WATTS BAR NUCLEAR PLANT (WBN) UNIT 1 - AMERICAN SOCIETY OF
MECHANICAL ENGINEERS (ASME) INSERVICE INSPECTION (ISI) PROGRAM
REQUEST FOR RELIEF PDI-2 - RESPONSE TO REQUEST FOR ADDITIONAL
INFORMATION (TAC No. MD4448)

**WATTS BAR NUCLEAR PLANT (WBN) UNIT 1
AMERICAN SOCIETY OF MECHANICAL ENGINEERS (ASME)
INSERVICE INSPECTION (ISI) PROGRAM REQUEST FOR RELIEF PDI-2
RESPONSE TO REQUEST FOR ADDITIONAL INFORMATION**

Figure 1

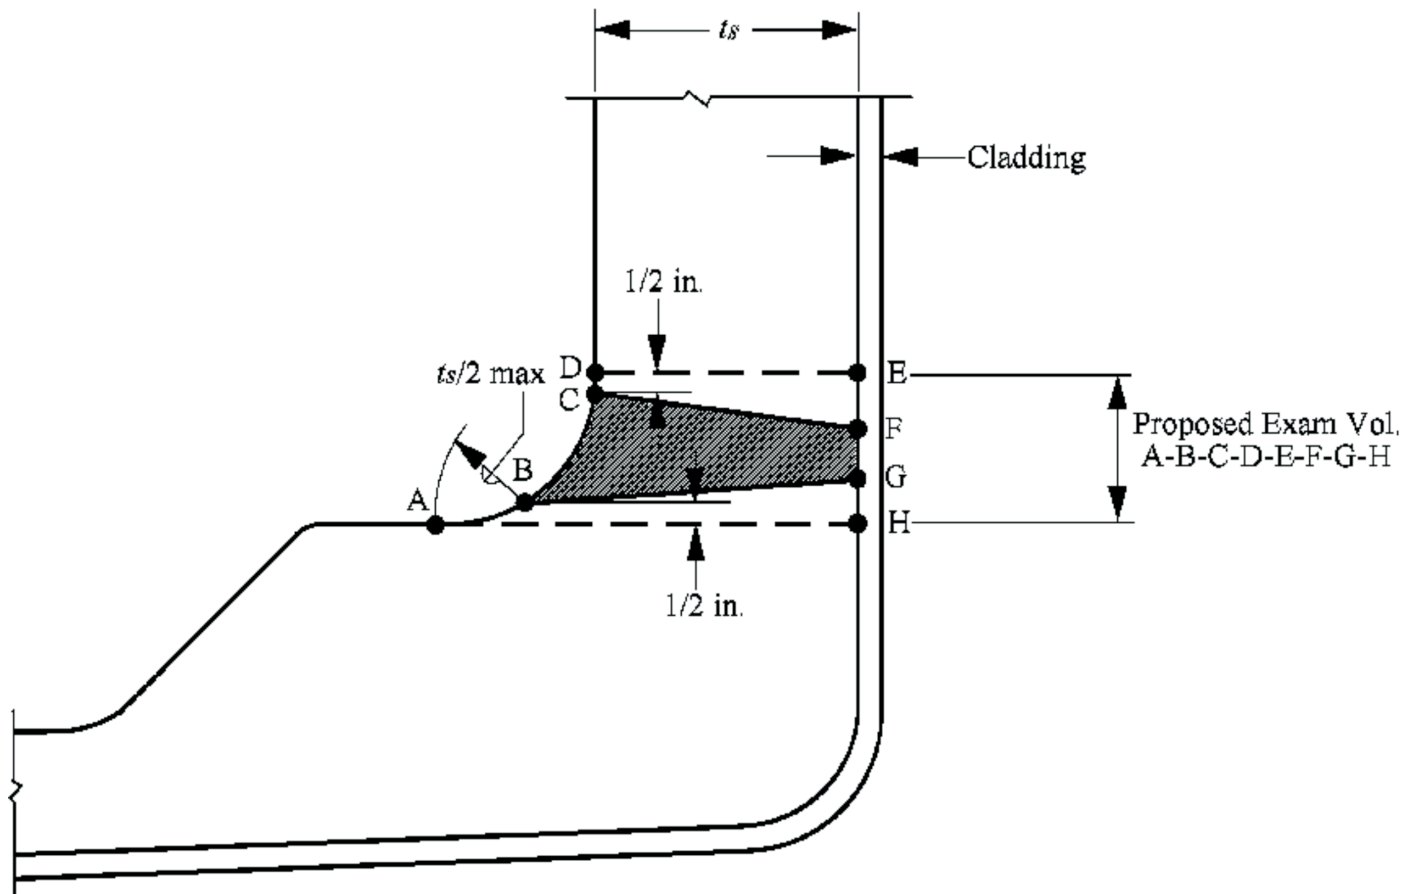
Provide supplemental sketches showing the specific configuration nozzle-to-vessel weld and revised examination volume (including dimensions).

The examination volumes for the nozzle to vessel welds are provided in Figures 1 and 2. Specific configurations and dimensions of the shell (t_s), nozzles, and cladding are shown in figures 3 and 4.

Figure 4

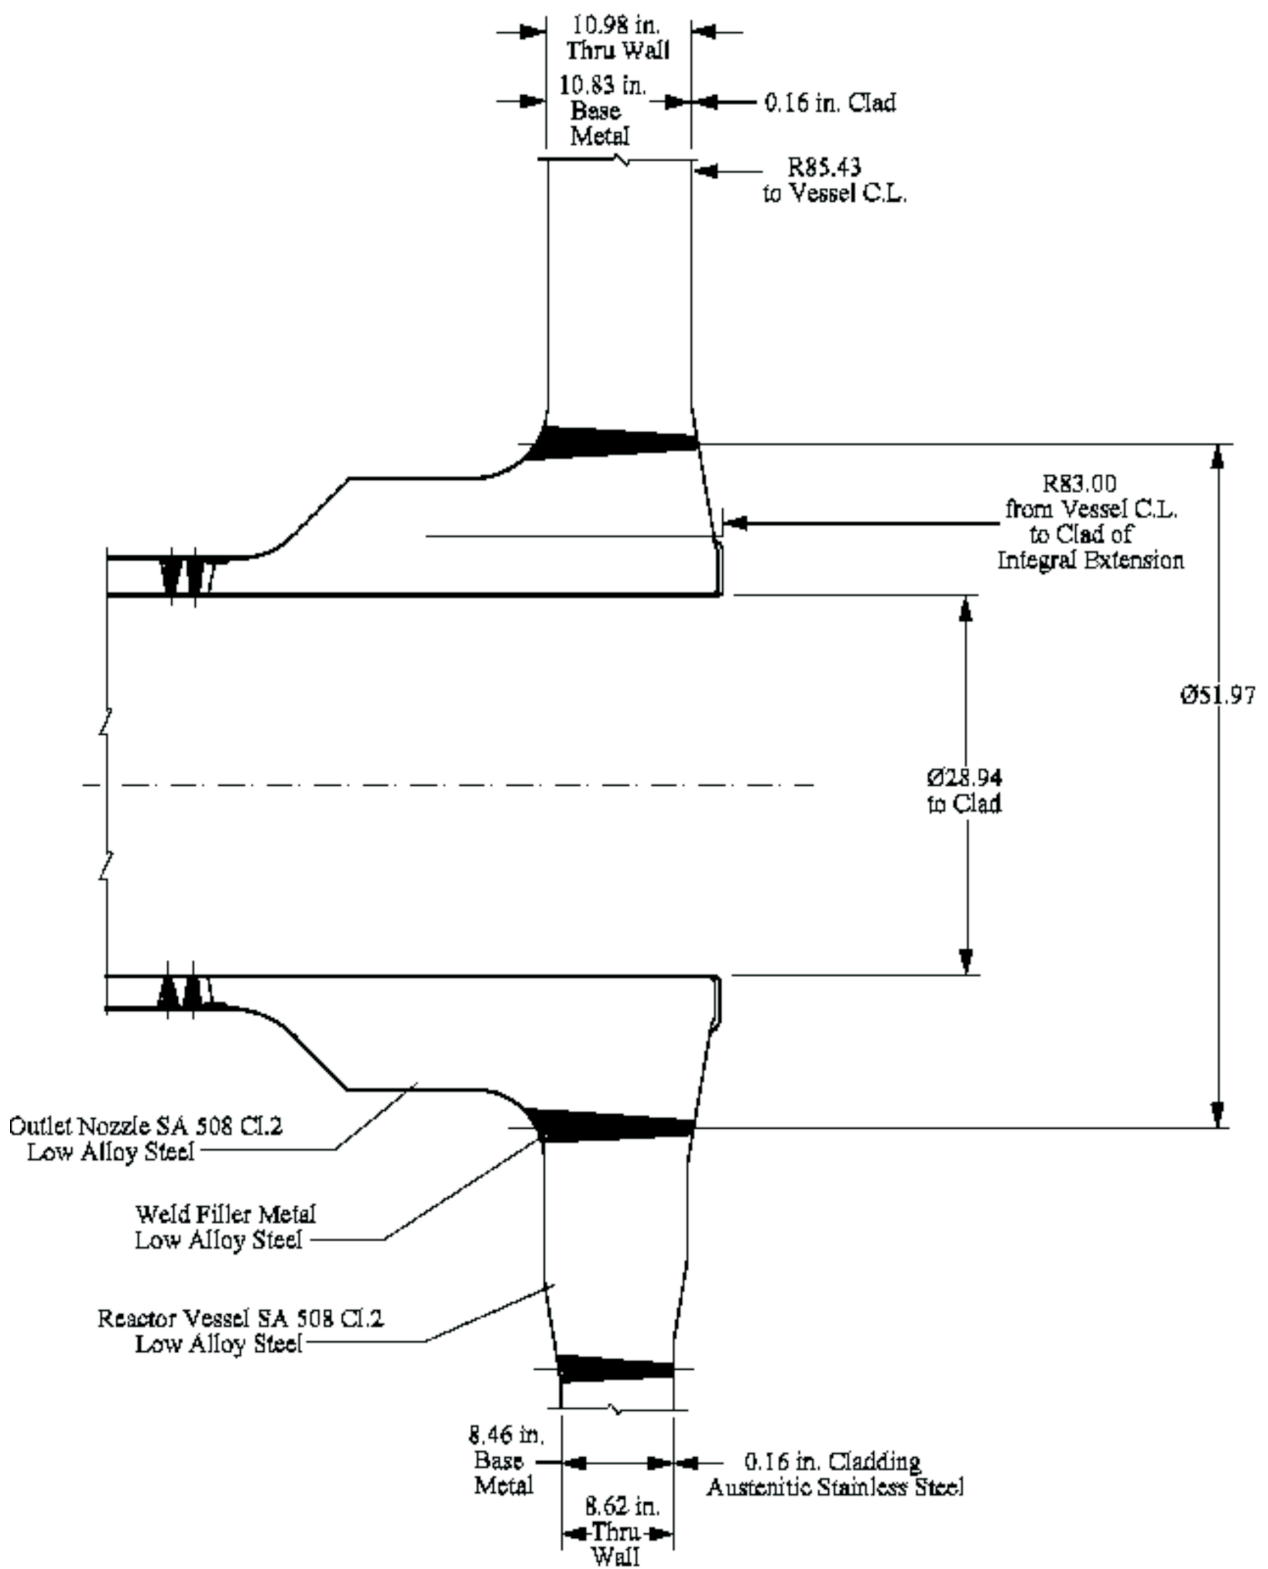
Identify the ultrasonic technique (manual or automated), nominal pipe diameters, and weldment material (ferritic, austenitic stainless steel, Inconel) that TVA is proposing to inspect.

Figures 3 and 4 depict the applicable nozzle configuration, dimensions, and weldment materials.
